TOWN OF MAMMOTH LAKES ZONING CODE UPDATE

Testing of Draft Commercial Zoning Standards

Downtown Working Group Meeting, January 28, 2013

Site A

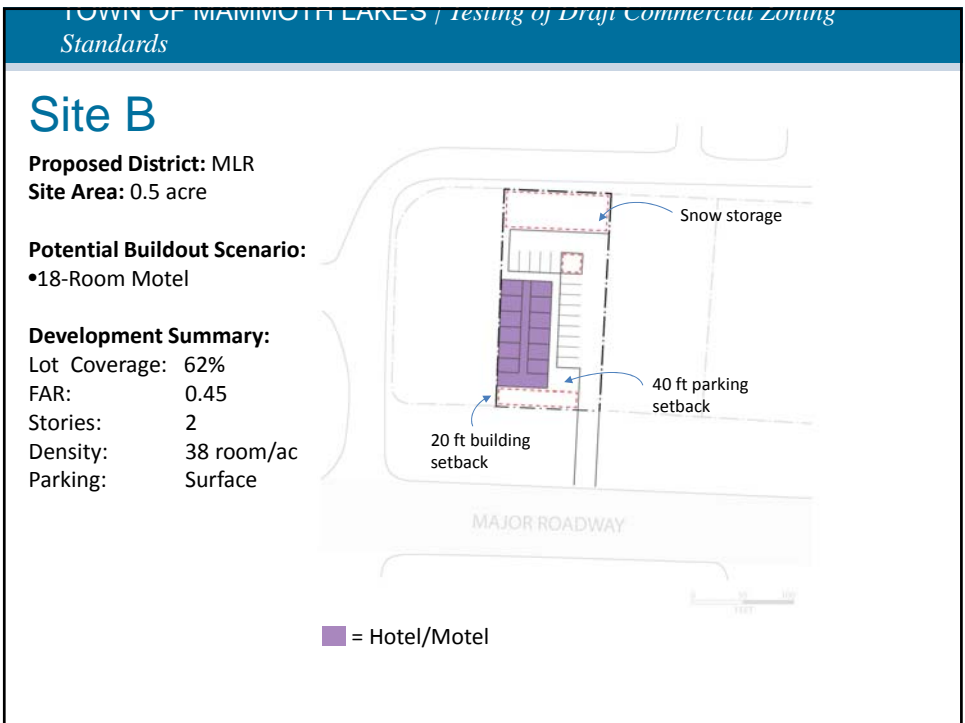
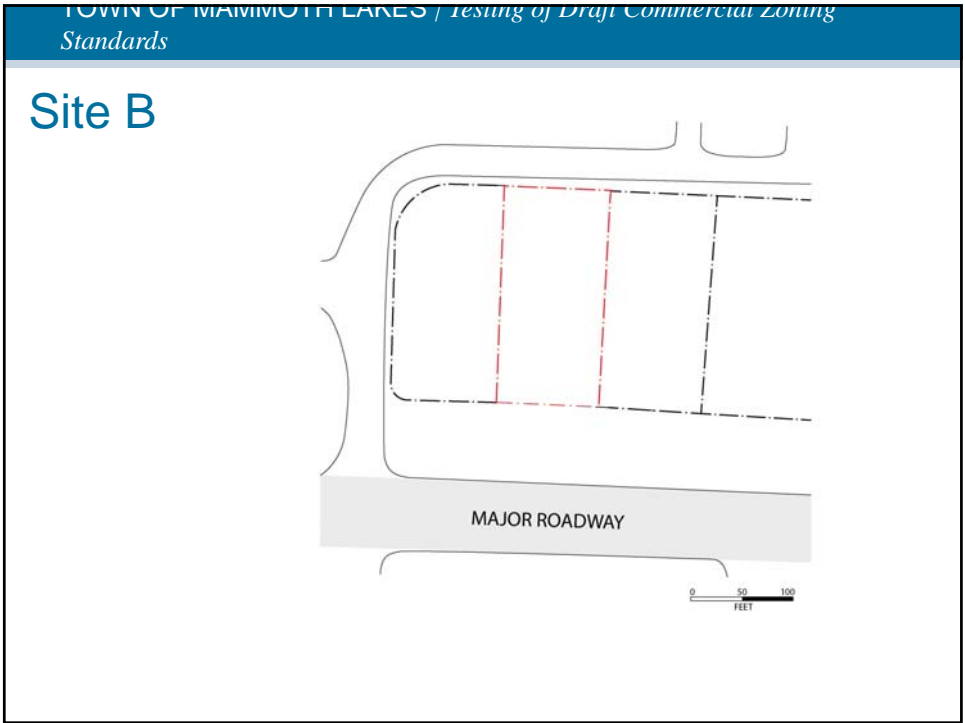
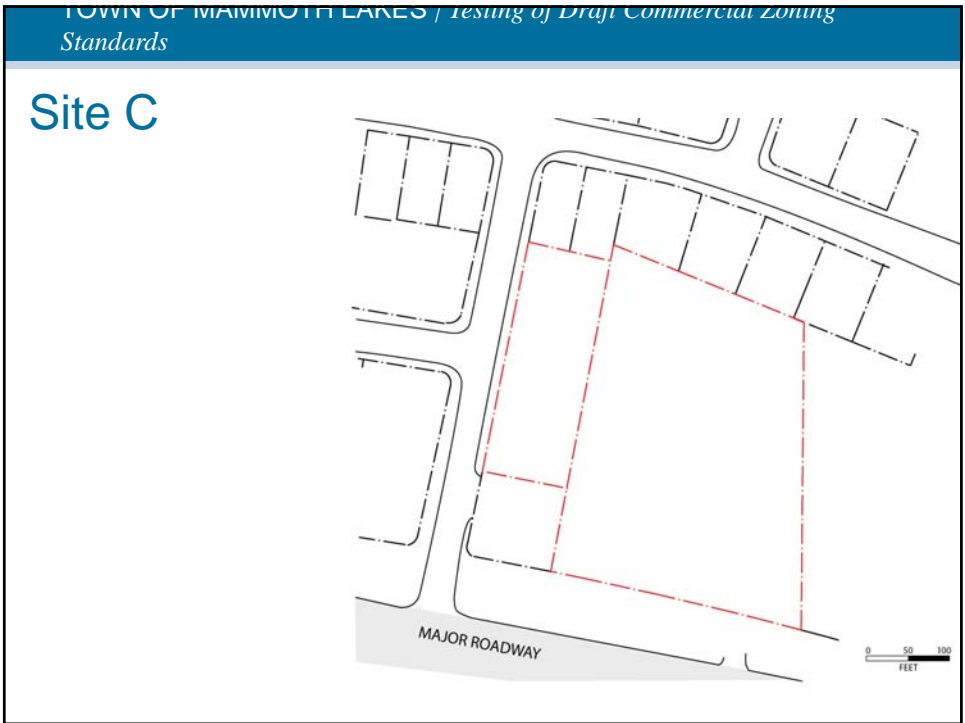
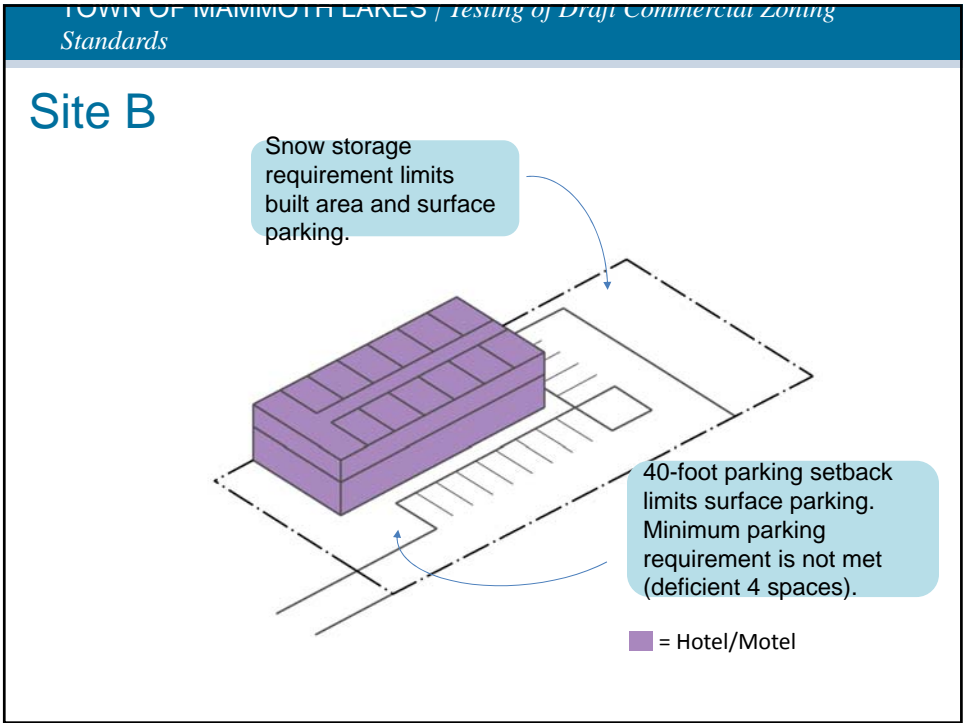
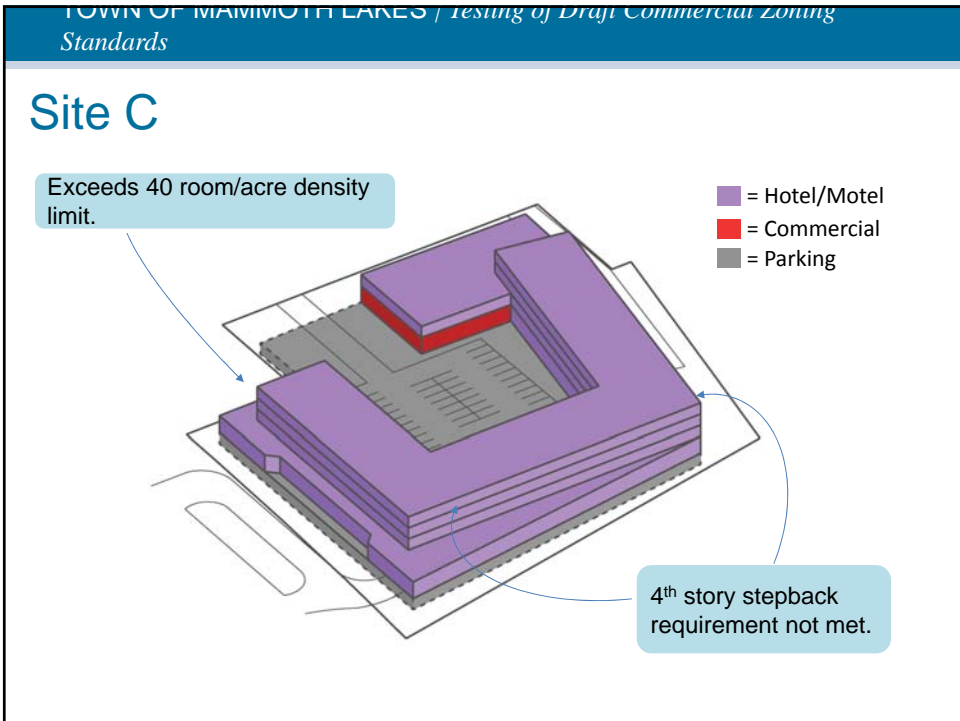
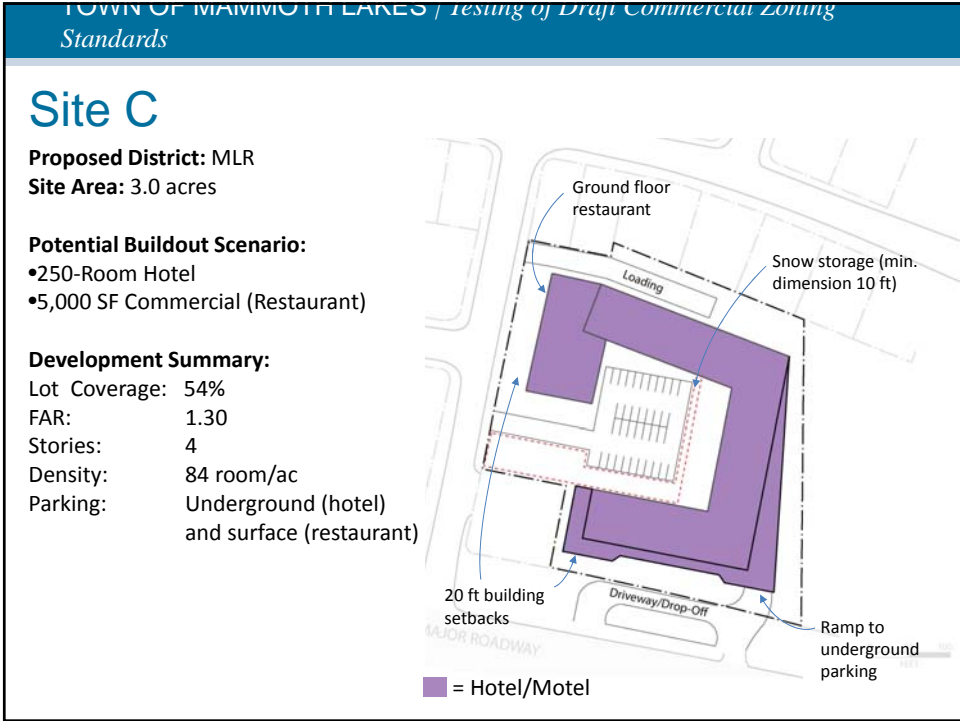
4th story stepback requirement not met on all facades.

Exceeds 40 room/acre density limit.

MLR District: Conclusions and Items for Discussion

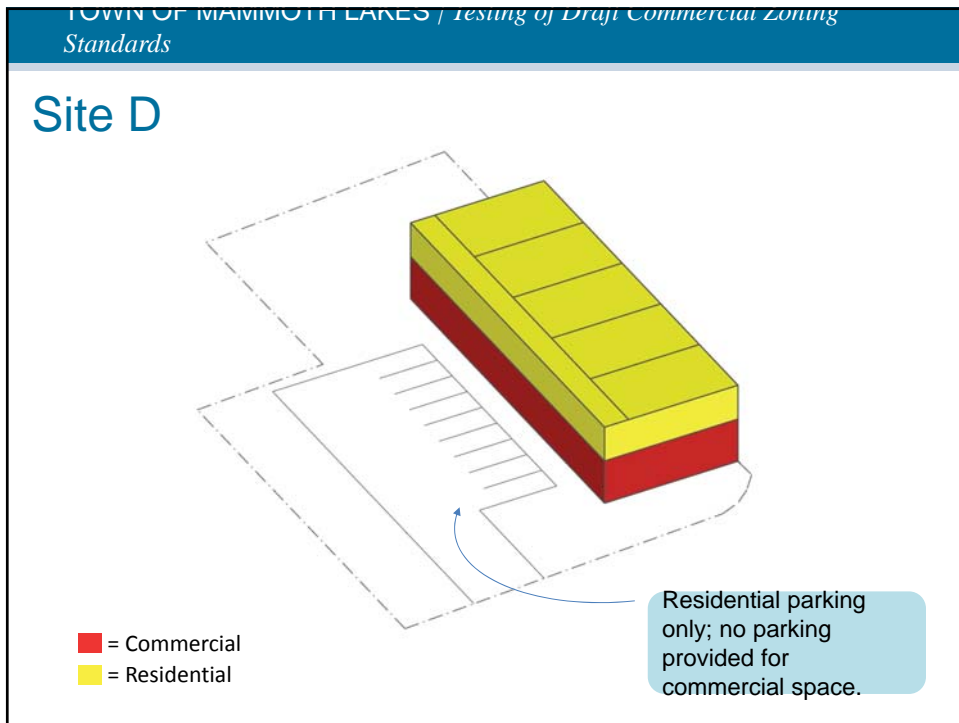
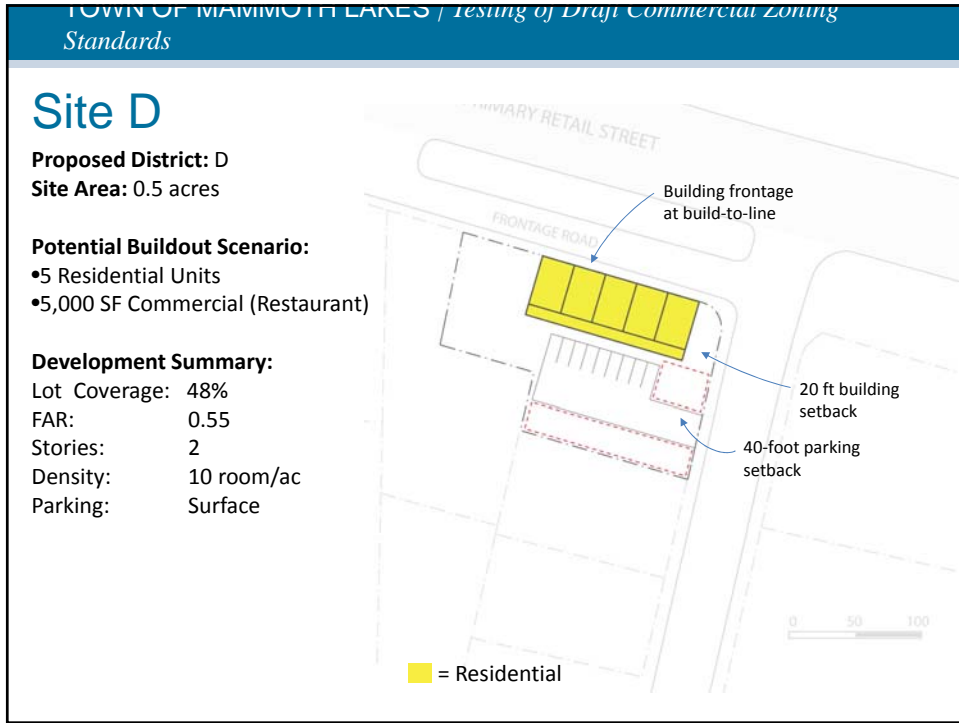
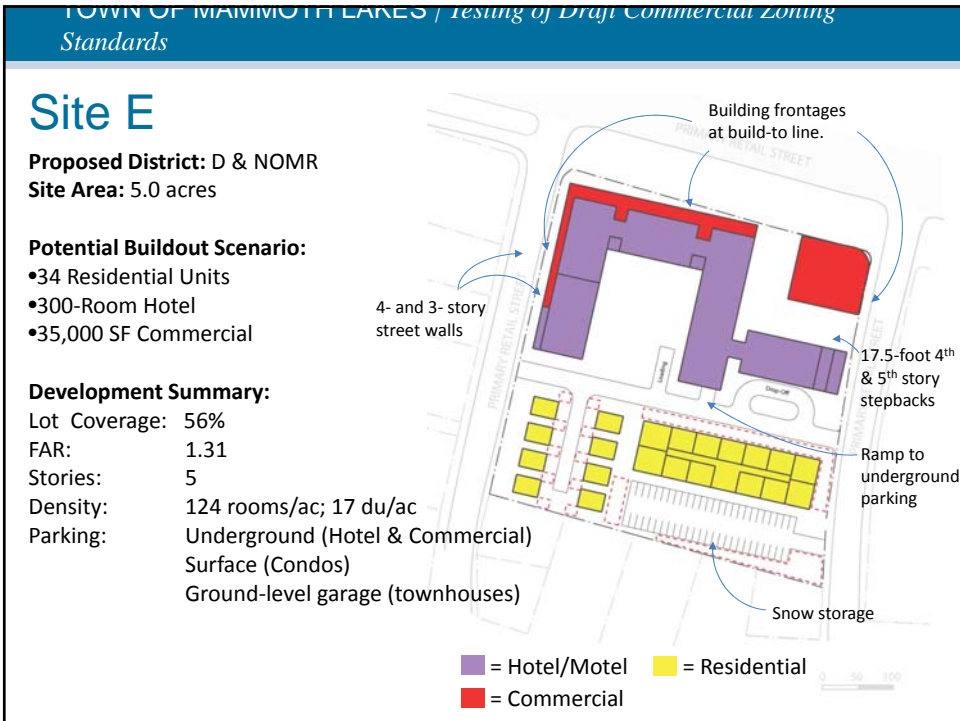
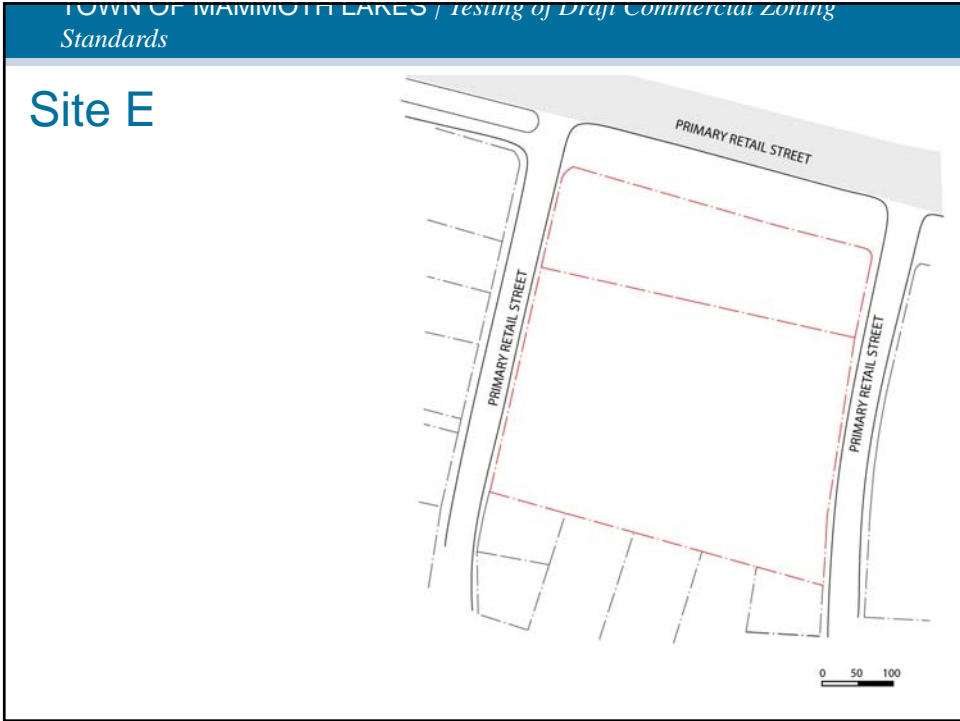
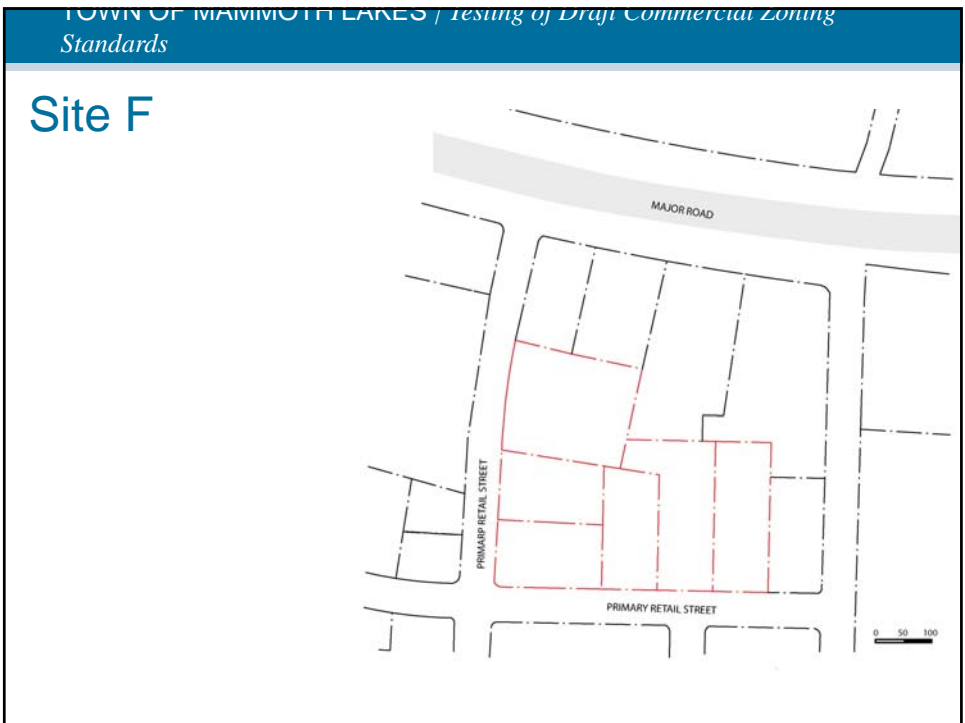
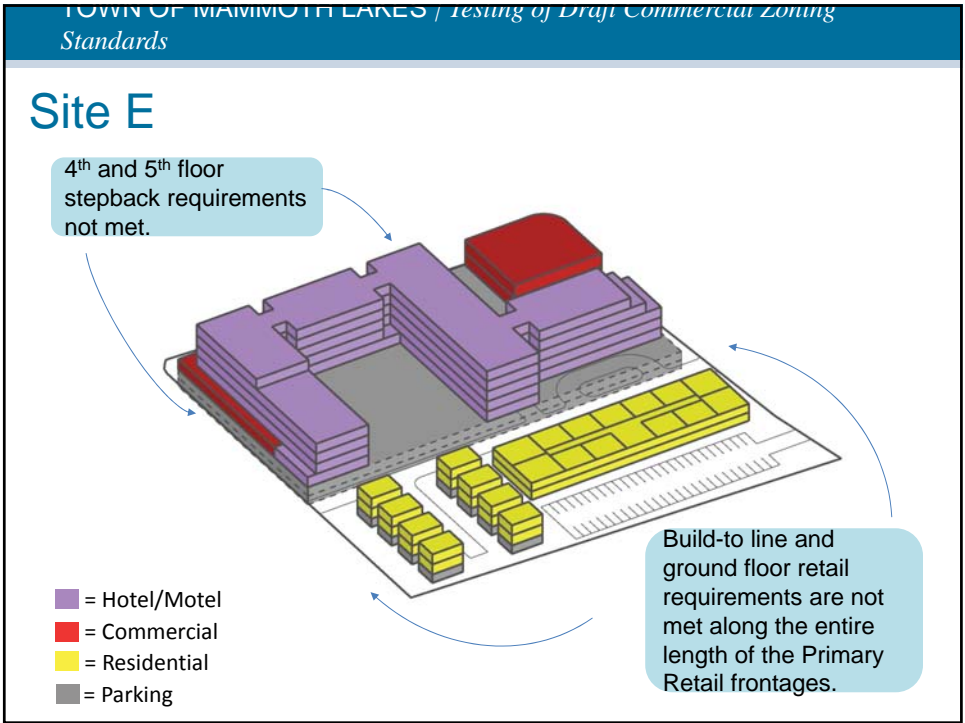
1. 40 room/acre density limit is exceeded on sites A and C. Consider increasing limit.
2. Snow storage requirement limits development potential. Consider reducing requirement on properties with a wide landscaped area between the roadway and property line.
3. 40-foot parking setback limits development potential on small sites. Consider waiving or reducing requirement for properties with a wide landscaped area between the roadway and property line.
4. 4th story stepback is not easily achieved with typical hotel dimensions (60- to 70-foot double loaded corridor). Consider exempting hotels from setback requirement; requiring setback on street-facing frontages only; or establishing height “zones” instead (based on distances from the property line rather than from the face of the wall on the floor below).

Site D

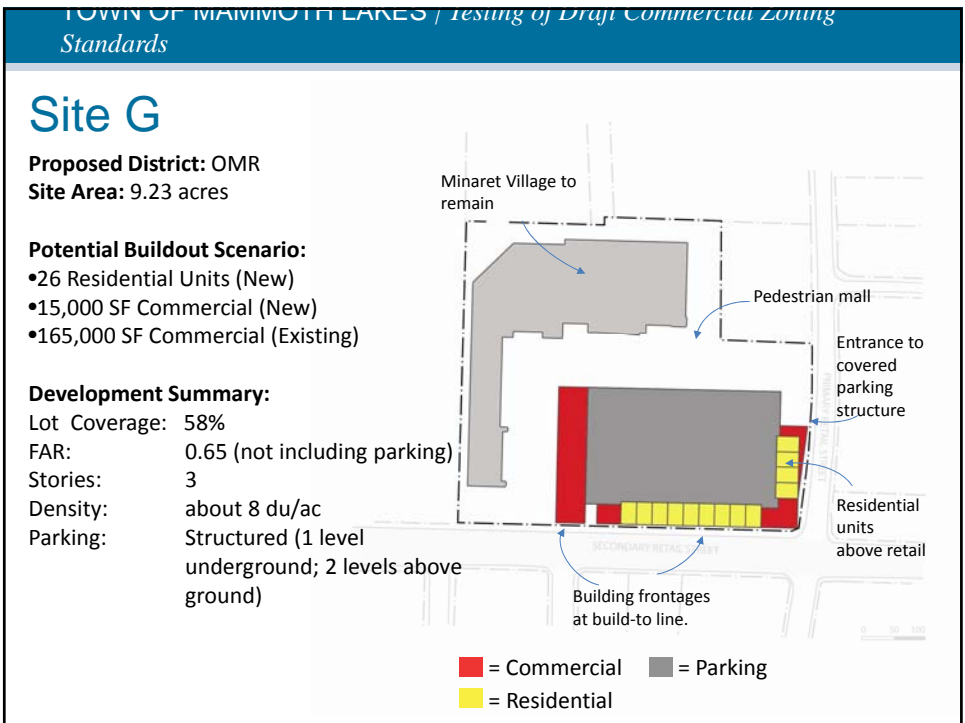
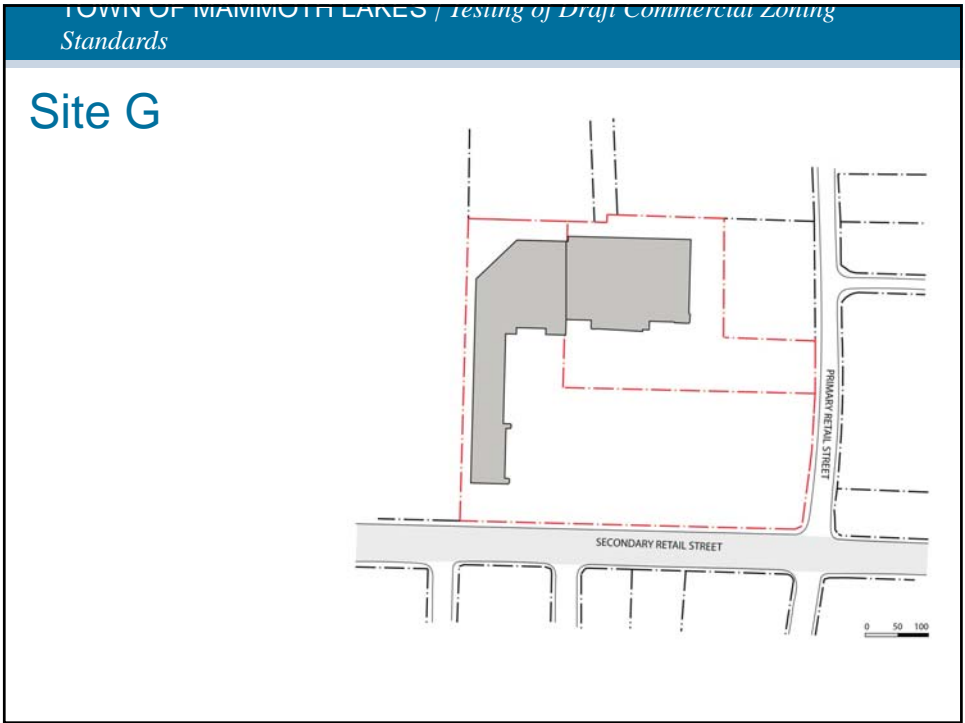
1. 4th and 5th story stepbacks are not easily achieved with typical hotel and residential dimensions (60- to 70-foot double loaded corridor). Consider establishing height “zones” instead, to be based on distances from the property line rather than from the face of the wall on the floor below.

2. The 40-foot parking setback limits development potential and surface parking on small sites. Consider waiving requirement for small properties and for properties along frontage roads.

4. The build-to requirement was typically not achieved along entire block frontages. Identify a percentage of block frontage that must be built to the build-to line (e.g., 50%). Alternately, establish an “active frontage” requirement, as a percentage of linear street frontage.

Site G

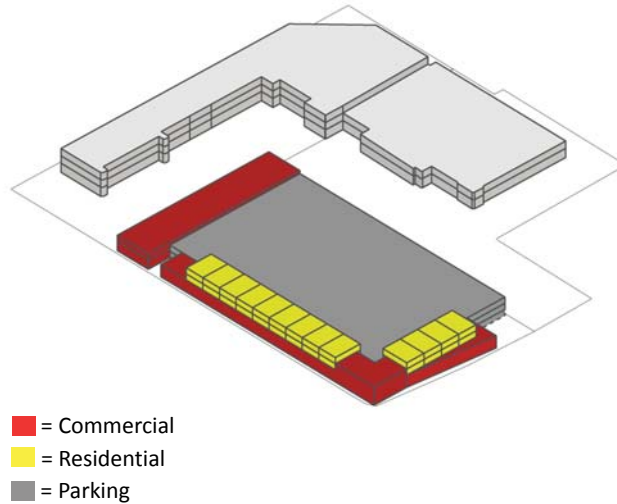
4. Primary and Secondary Retail Streets may merit different built-to standards. Consider further reducing the requirement for Secondary Retail Streets.

5. The maximum 10-foot setback allowed within Retail Frontages is insufficient for some outdoor seating, patios, etc. Consider increasing this allowance.
